工程指示 / 要求簡箋 ENGINEER INSTRUCTIONS(E.I.)

工程指示編號:	EI- 8378	修改版本:	C
	HK- 1910		
工程編號:	J 861	工程名稱:	己連拿利
收件人:	生統	發件人:	細佬
工程項目:	預制窗-試模窗	日期:	21/10/2024

TITLE : TYPICAL DETAILS FOR PRECAST WINDOW

DWG NO. : J861-SD-PW-3003 REV. : A

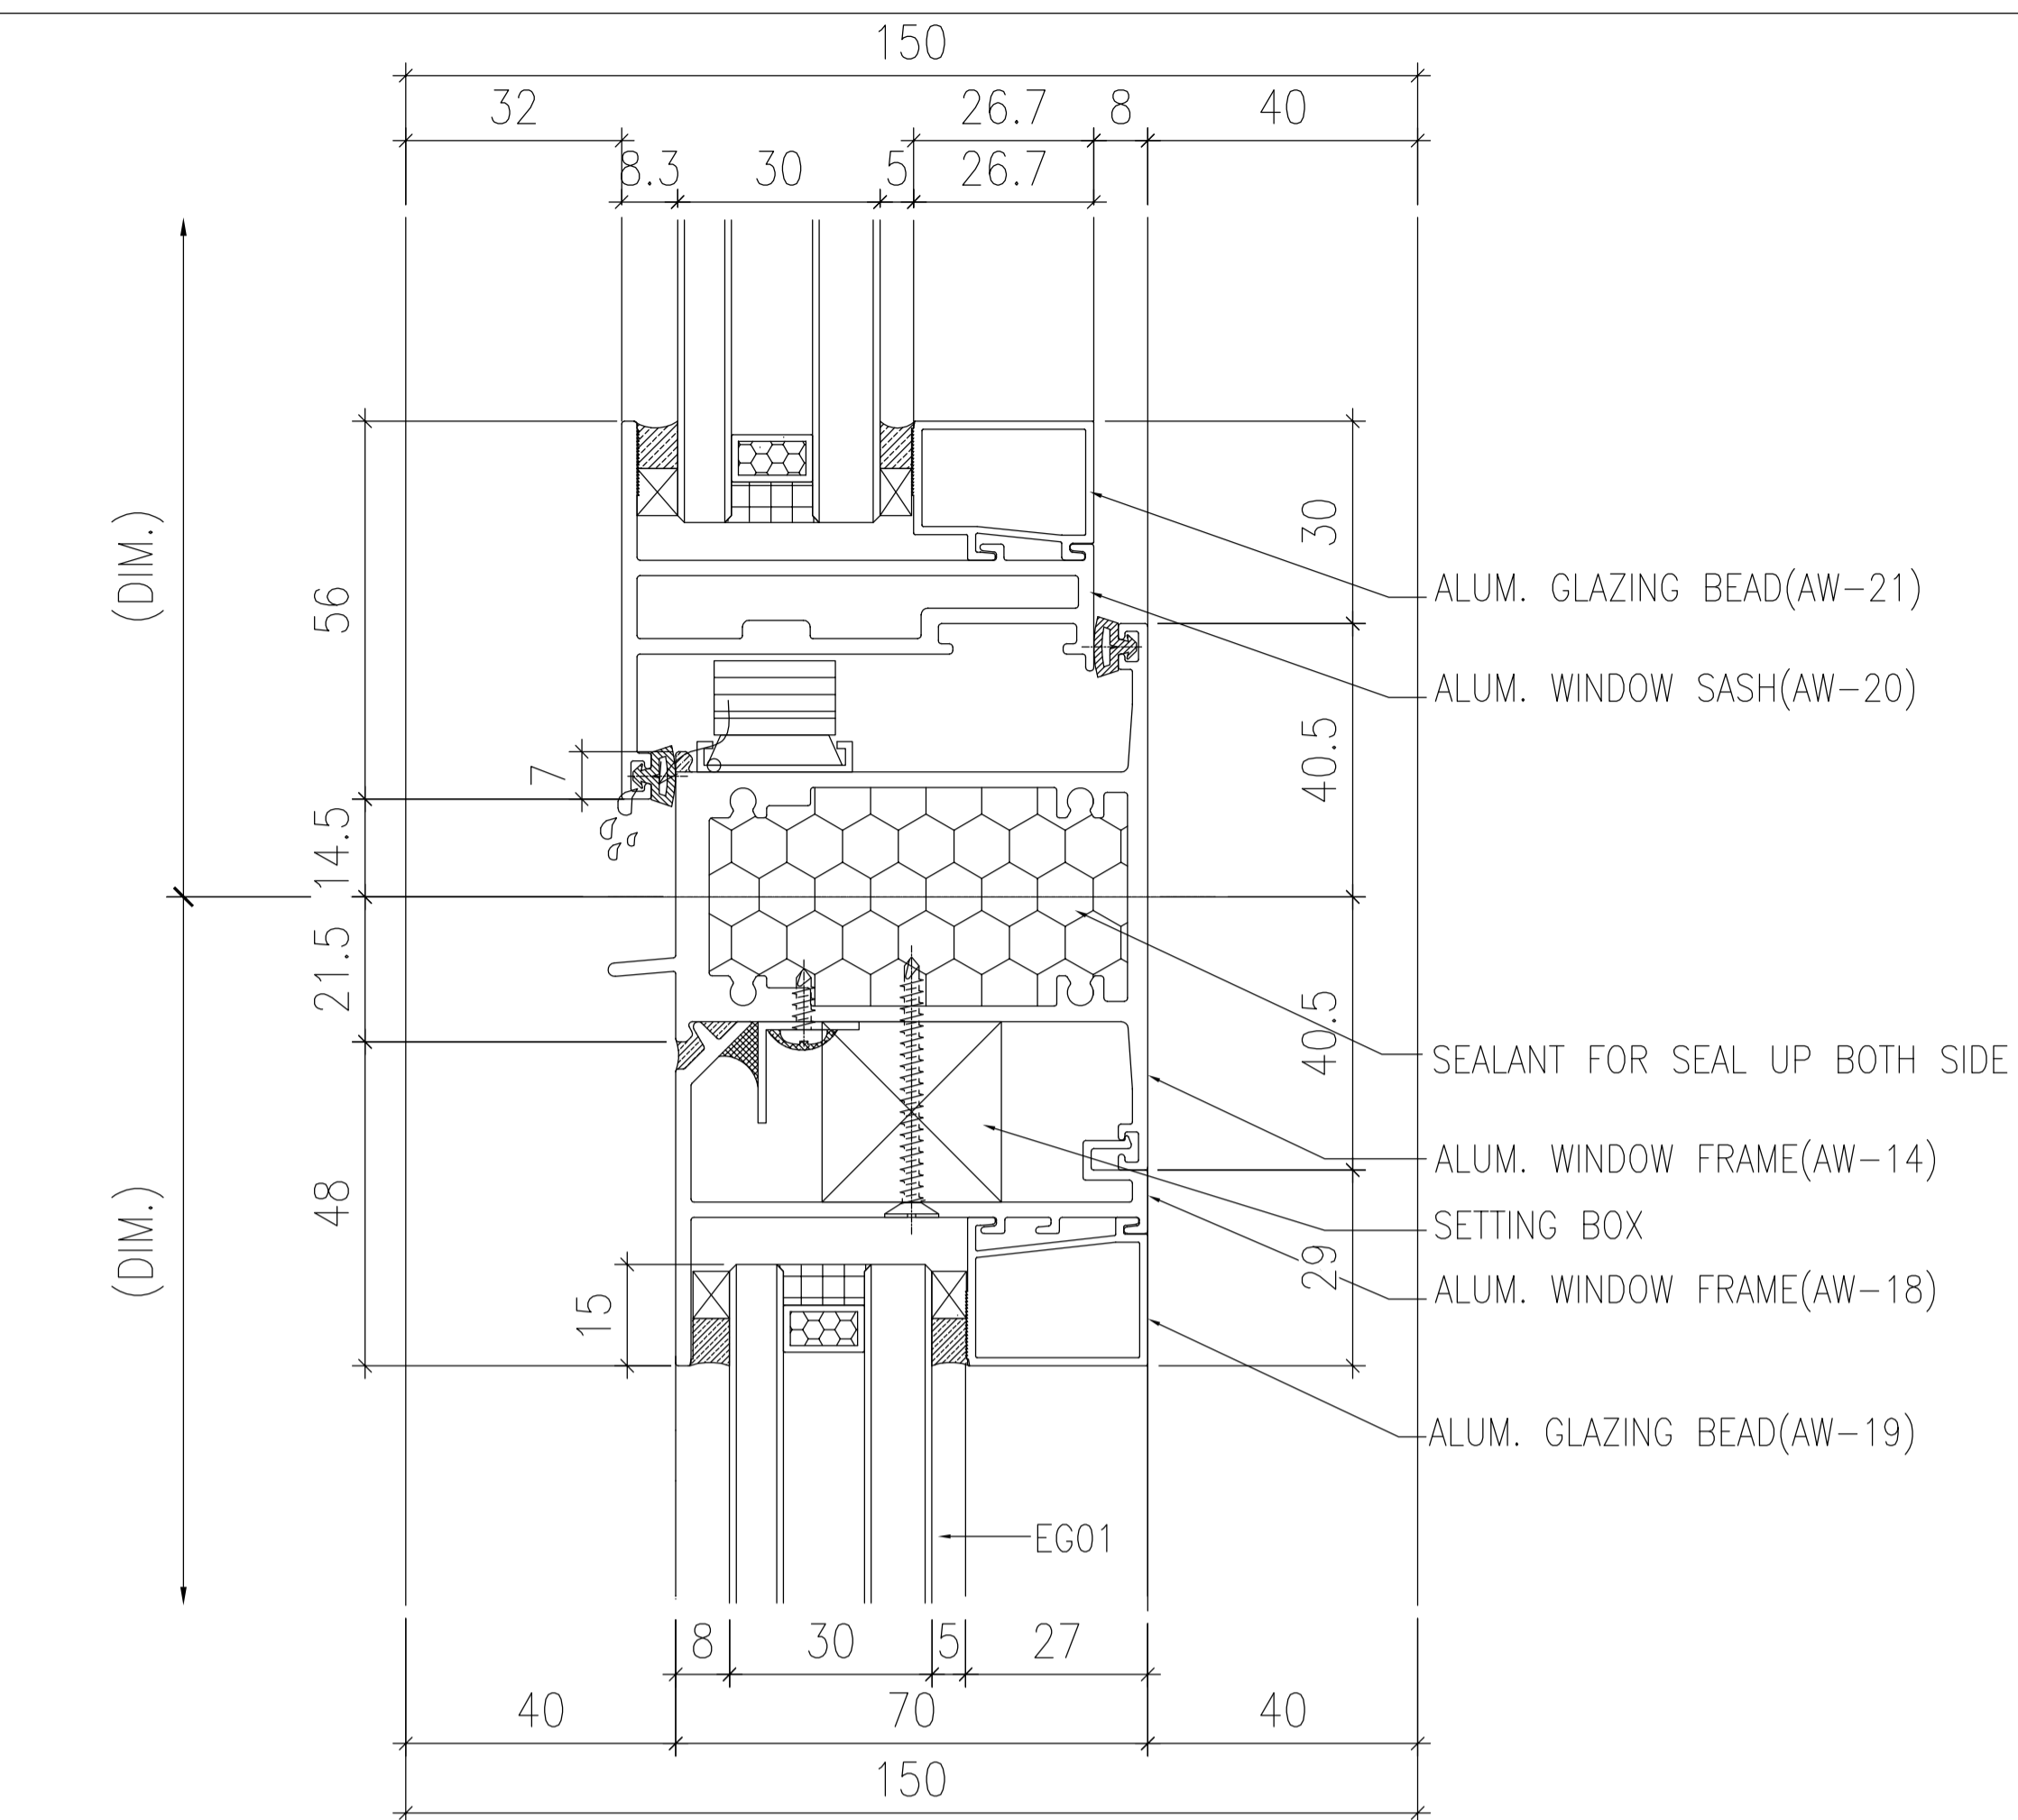
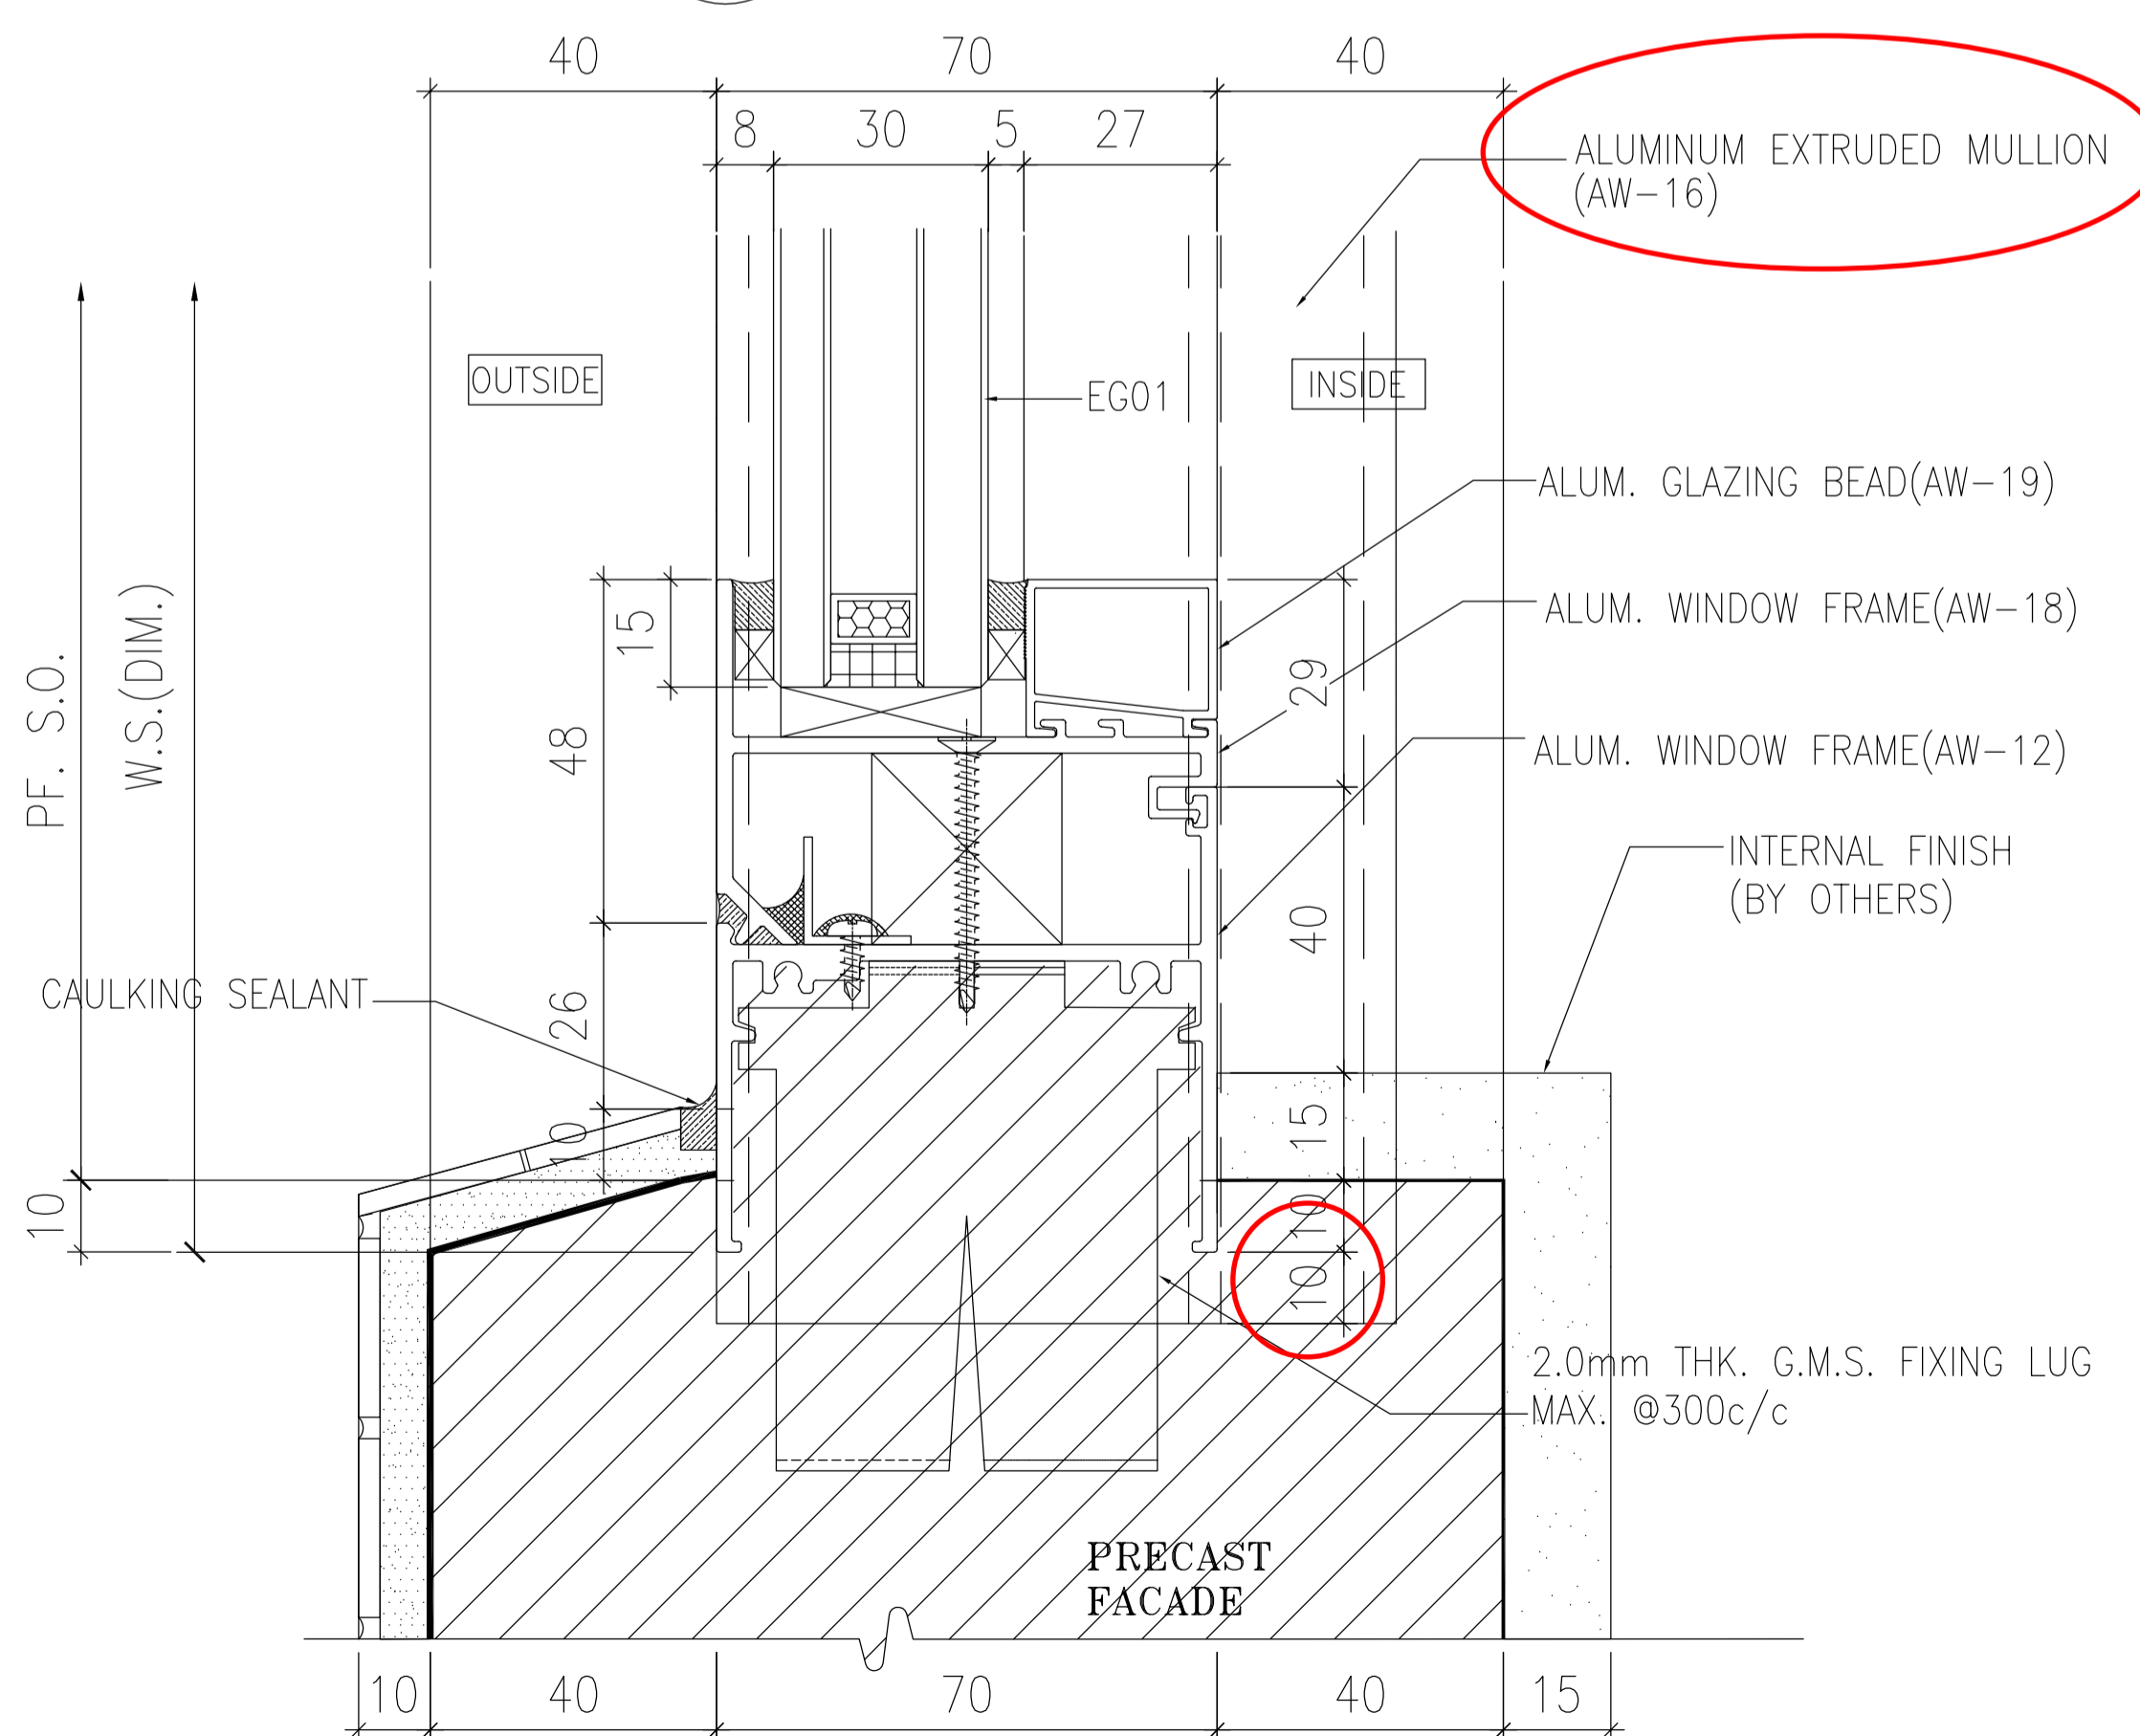
內容: 夾通要突出10mm 附頁施工圖圖號3003 試模窗的[夾通]如已開料,請按附頁方案夾通加長10mm
完成上列要求日期: 23/10/2024

試模窗 TW-07 頂底 補 10mm 夾通 方案
 夾通 補成 2580mm
